Workgroup Consultation Response Proforma

CMP435: Application of Gate 2 Criteria to existing contracted background

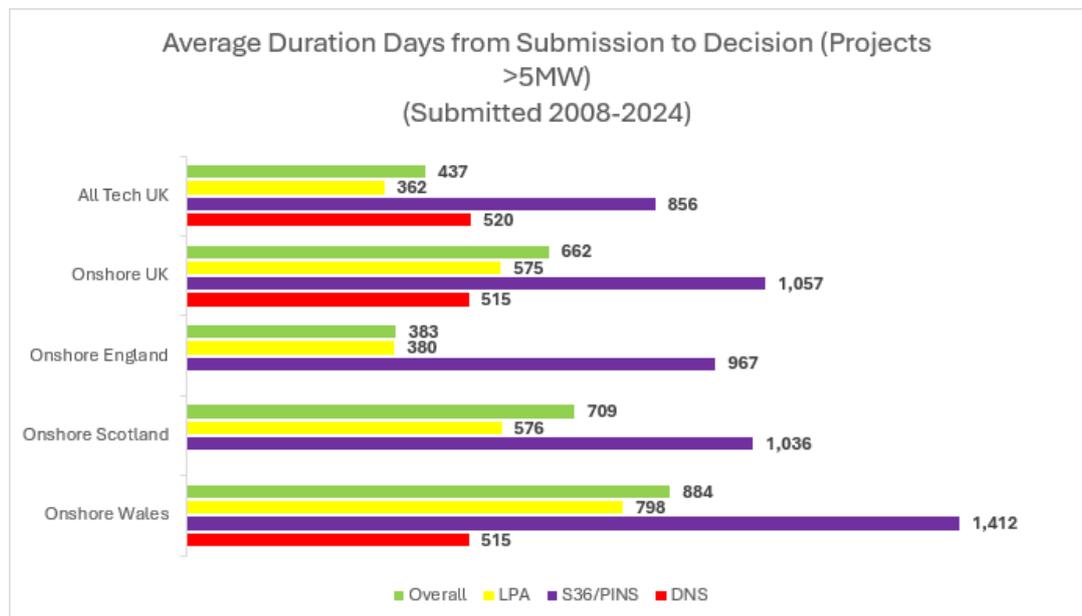
Additionally, most members support the Workgroup Members proposed timescales over the Proposal as set out on Page 24 (CMP434), but importantly flag that there should be alignment across Scotland and England for Section 36 & 37, with a timescale in line with a DCO. If consenting an onshore development in Scotland, it could feasibly require the same length of time as a DCO. An analysis of RenewableUK EnergyPulse database shows associated with projects seeking planning between 2008 and 2024 that are >5MW. The following chart presents the results:

Section 36 is shown to take considerably longer than Town and Country Planning, thus aligning the two as proposed is not deemed to be equitable or based on evidence. Note, this does not include additional delays due to appeals.
